Product / Process Change Notification (PCN)

PCN #: PCN_WCAP-FTXX_20221008

Affected Series: WCAP-FTXX; 890334xxxxxx

Example old drawings with indirect dimensioning

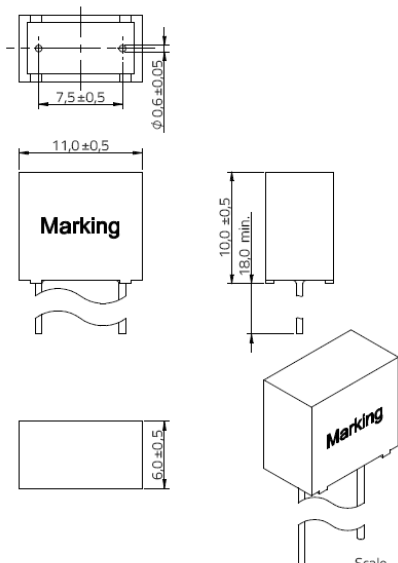
All corrections in terms of mechanical characteristics are shown. In order to visualize the corrections of the dimensions, an example of the old and the new drawings is shown below. Würth Elektronik will update the dimensioning from an indirect dimensioning to a direct dimensioning:

In the course of the update from indirect to direct dimensioning, the values for the dimensions and tolerances will be updated. The upcoming corrections can be seen more detailed in the pictures above.
